SUBJECT: Forwards WNP-2 Emergency Plan, Rev 20, IAW 10CFR50.4(b),  
 50.54(q) & 10CF50 App E. Detailed synopsis of changes is also  
 provided.

Subject: **WNP-2 OPERATING LICENSE NPF-21  
TRANSMITTAL OF REVISION 20 TO THE WNP-2 EMERGENCY PLAN**

# EMERGENCY PLAN

## EMERGENCY PLAN FOR WNP-2

Figure 1-1, Ten-Mile Emergency Planning Zone (EPZ)

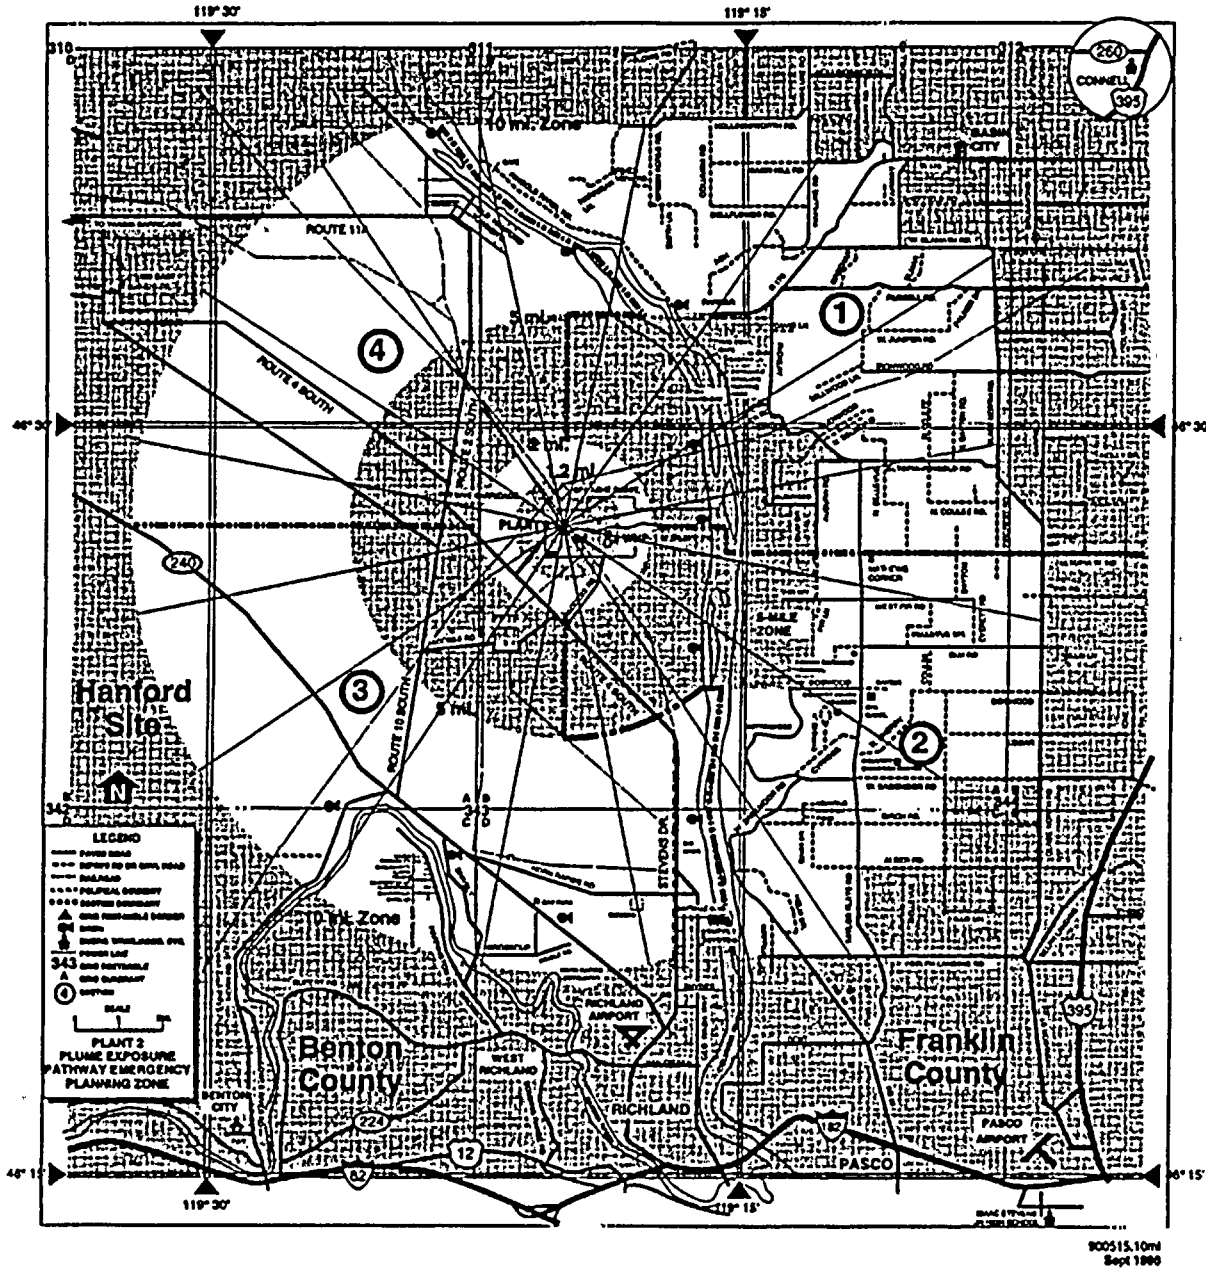
- EP 1.16 Updated Figure 1-1 to include the Horn Rapids area in Sector 3.
- EP 2.1 Minor editorial correction in section 2.1. Clarified the description of how maintenance functions are satisfied in the absence of craft in section 2.2. Added text to indicate that the STA responsibilities may be performed by other personnel on shift. Removed the Shift Technical Advisor position from 2.2, as the function is adequately described in 2.1. Added a statement to indicate that Security and Control Room personnel have 24 hour communications capability with offsite response agencies.

Figure 2-1, Emergency Response Organization Chart

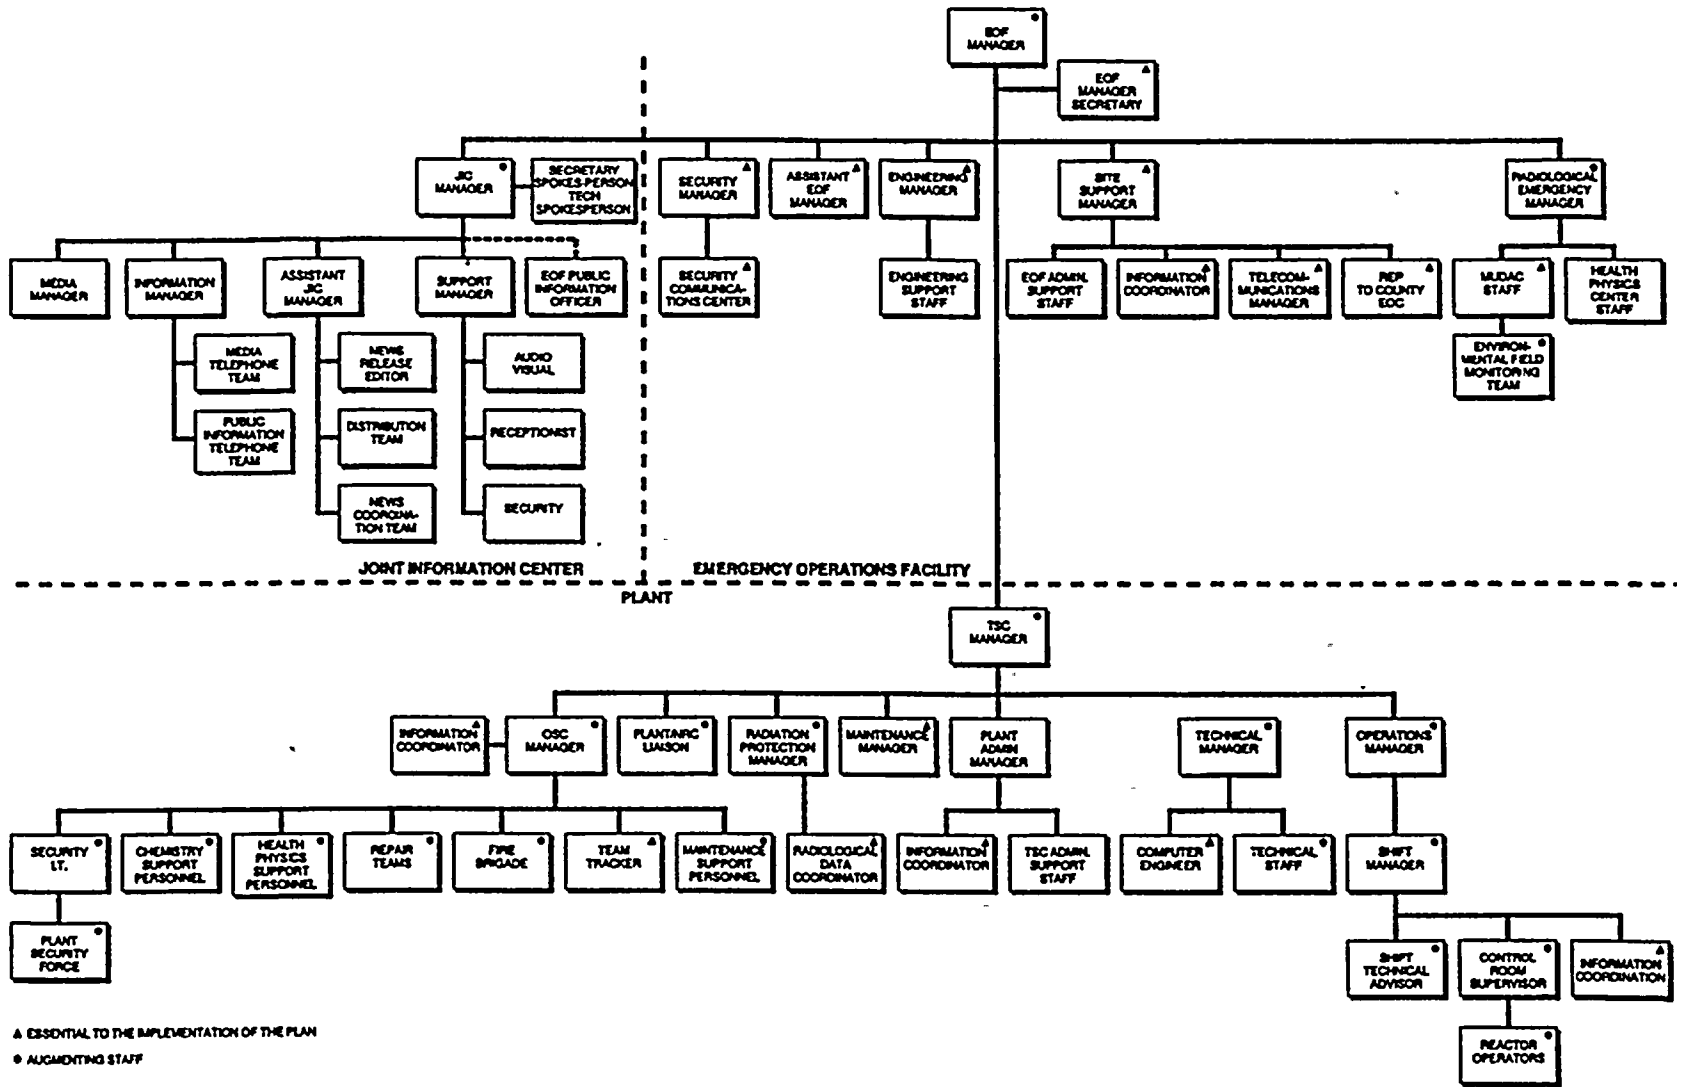
- EP 2.17 Corrected the legend for Figure 2-2 and relabeled to Figure 2-1. Added Manager to Joint Information Center, and used the acronym for brevity. Removed the security positions branch from the OSC Manager line and attached it to the Security Manager reporting scheme; it was editorially corrected for clarification.
